febi 26775

To fit:
Mercedes Benz CDI engines

Repl. No. 646 200 05 70

Belt tensioner

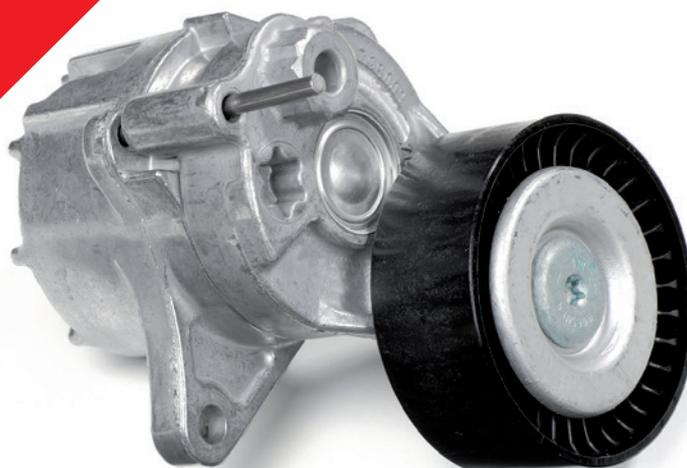
For design reasons, when the vehicle is driven with the original version of the belt tensioner installed (ref. no. 611 200 04 70), noise may occur (The manufacturer has now replaced this version).

The noise is generated because the spring is too long and makes direct contact with the base of the housing (1). Only the spring's torsional characteristics are important for this application (2), (6).

The noise is caused when the spring touches the cast-in hollow pin (3) and the base of the housing (4).

febi supplies the belt tensioner febi 26775 (ref. no. 646 200 05 70) for the free aftermarket.

A highly wear-resistant plastic bushing (5) distance the spring from the base of the housing and prevents metal-to-metal contact where the spring is located. Since only the springs's torsional characteristics are important the height has been reduced (6).

The spring makes contact with the plastic bushing (7) and is therefore prevented from touching the base of the housing. No noise can therefore occur. In the new version (8), a steel pin has been cast in the base of the housing in order to center the spring.
